PG&E Letter DCL-03-113

Docket No. 50-275, OL-DPR-80  
Diablo Canyon Unit 1  
PG&E Response to NRC Questions on 1R11 Steam Generator Tube Inspections

**PG&E Response to NRC Questions on 1R11 Steam Generator Tube Inspections**

Figure 1

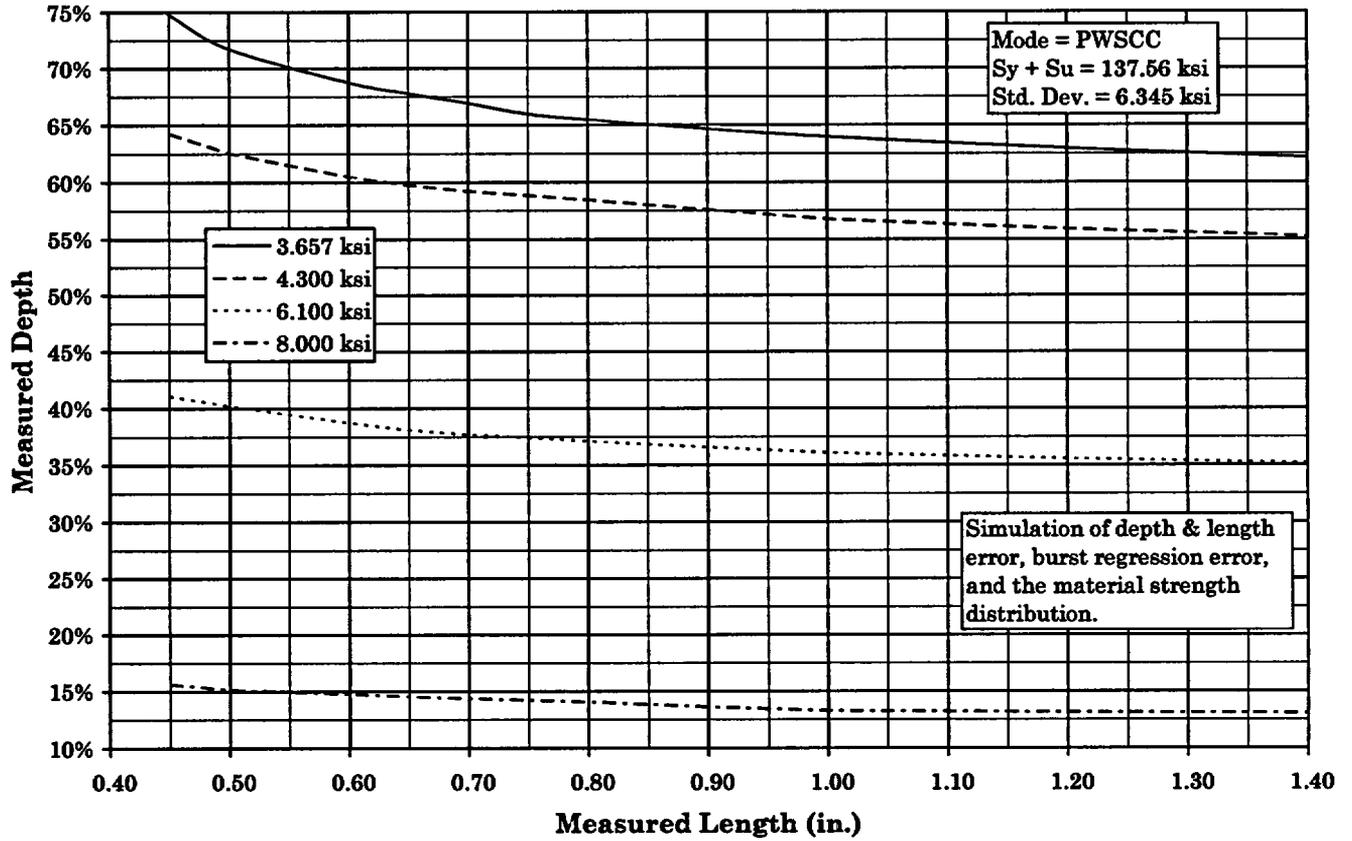
“An evaluation was provided regarding the ability of the operational assessment methodology to predict flaw distributions as a function of flaw size. This evaluation focused on the predicted burst pressure of the specimens. Whereas the burst pressure gives insights on the severity of the degradation, it does not directly verify whether the methodology for predicting the length and depth of the degradation provides conservative results (i.e., the predicted burst pressure may be accurate but for the wrong reasons). In addition, given that the computer code for predicting the burst pressure only provides an actual estimate of the burst pressure when it is less than some cutoff value (e.g., 6100 psi), it would not provide information that would indicate whether under predictions of the burst pressure were being made (unless most burst pressures were less than this cutoff value). That is, suppose the predicted burst pressure for EOC 12 was 9000 psi, the computer code would only indicate that it was greater than 6100 psi. If in this case, the actual burst pressure was determined at the EOC 12 to be 6500 psi, the methodology would have under predicted the burst pressure by 2500 psi. Whereas this specific example does not pose a safety issue, it may provide an early indication that the methodology is not providing conservative results. Please discuss your plans to address these issues in future assessments.”

As previously discussed with the NRC in PG&E letter DCL-02-045, “Response to Final NRC Request for Additional Information Regarding Supplement 3 to License Amendment Request 00-06, ‘Alternate Repair Criteria for Axial PWSCC at Dented Intersections in Steam Generator Tubing,’” dated April 18, 2002, the distribution of burst pressures above 6100 psi is not considered to be important for tube integrity assessments. In addition, differences between projected and as found burst pressures where both burst pressures are greater than 6100 psi are not recommended for assessments of the adequacy of the methodology. The flaw sizes at the beginning of the cycle being projected are very small where nondestructive examination (NDE) uncertainties are large and differences between projections and as found burst pressures can be significant with no implications on the adequacy for tube integrity analyses. Figure 1 plots average depth versus length requirements (at the 95/95 confidence levels used for burst analyses) to satisfy burst pressures of 8000, 6100, 4300 (near  $3\Delta P_{NO}$ ) and 3657 ( $1.4\Delta P_{SLB}$ ) psi. To satisfy burst pressures of 6100 psi and 8000 psi, the average depths must be less than about 35 percent to 42 percent and 16 percent, respectively, or less than a length of 0.45 inch for which even a throughwall indication satisfies burst margin requirements. If the indication is projected to have an average depth less than 40 percent such that the projected burst

pressure is greater than 6100 psi, and the as found indication has an average depth less than 40 percent to satisfy a burst pressure greater than 6100 psi, the methodology is considered to be very adequate even if the burst pressures might differ by 1000 psi above 6100 psi. Since the axial PWSCC sizing methods require the maximum depth to be at least 20 percent, predictions of burst pressures less than 8000 psi are essentially forced by the sizing methods. Consequently, there is no need to assess differences in burst pressures above 6100 psi and there is no need to revise the computer code to edit the high burst pressures.

Assessing the adequacy of the operational assessment methods based on burst pressure comparisons is considered to be more relevant and significant than separate comparisons of lengths and depths. Typically, when lengths are underestimated, the flaw has shallow tails that are not detected and the sizing would be expected to reflect a larger average depth over the detected length than would be obtained for the total length. If a length and/or depth was different between the projections and as found, the significance of the difference would have to be assessed by comparing the burst pressures. The sizing methods are considered to predict conservative results only if the burst pressure is conservatively predicted.

In summary, the current comparisons of projections and as found based on burst pressures less than 6100 psi and on SLB leak rates are considered to be the most appropriate and meaningful methods for evaluating the methodology. It is planned to continue these comparisons for future assessments.

**Figure 2. Flaw and Mix Residual (400/100 Mix) for Plant A-1 Pulled Tube R27C54-1H**

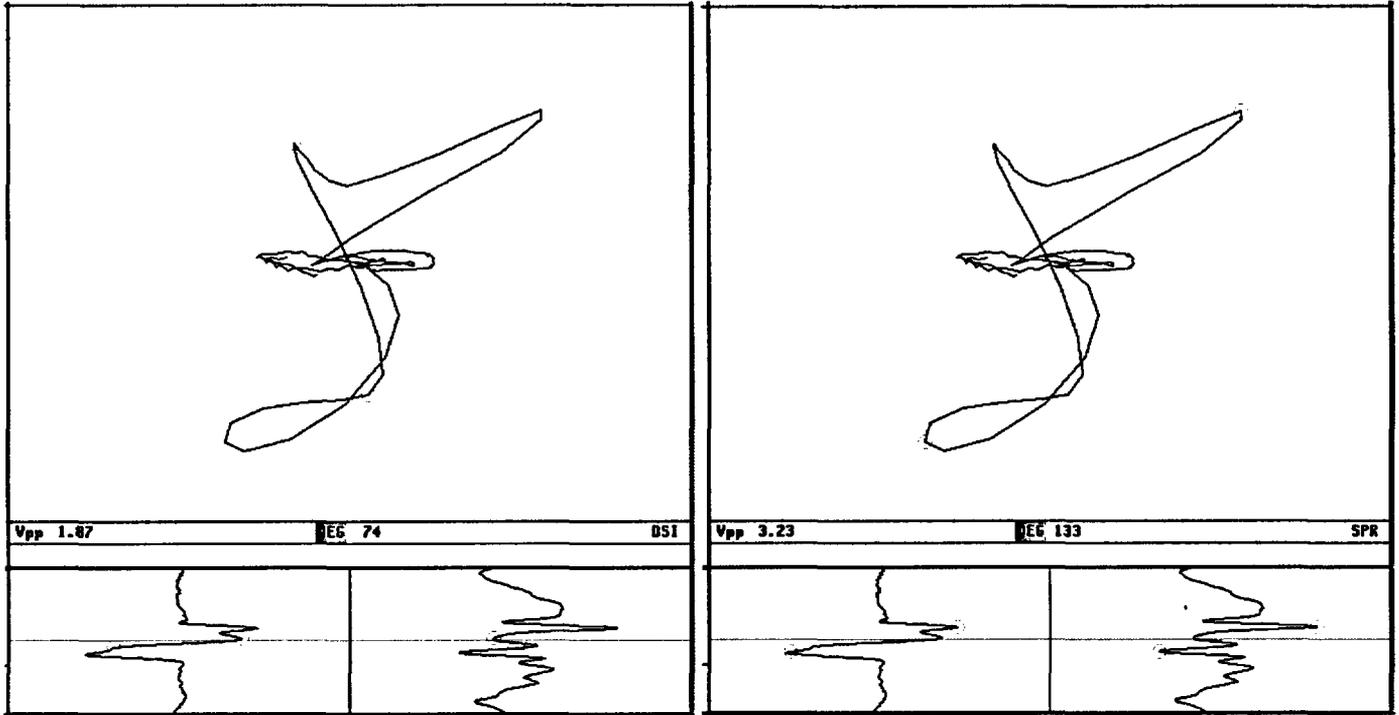
**“What is the basis for the 1 volt limit for support plate residual (SPR) indications? Discuss whether the voltage readings for indications located at SPR intersections are consistent with the voltage readings that would be obtained from the same indication if there was no support plate residual influence.**

Many of the pulled tubes in the ARC database (and the prior cycle probability of detection or POPCD database) have mix residual signals larger than typically found in currently operating SGs. Figure 2 shows the 1.87 flaw voltage and the 3.23 mix residual voltage for pulled tube R27C54 from plant A-1 in the ARC database. This is only one example of the pulled tube data. Whatever influence the mix residuals may have on voltage sizing for TSP indications is built into the ARC database by the pulled tubes. The mix residuals may be more easily understood as TSP noise. The noise may distort the flaw signal particularly when the two-phase responses are similar.
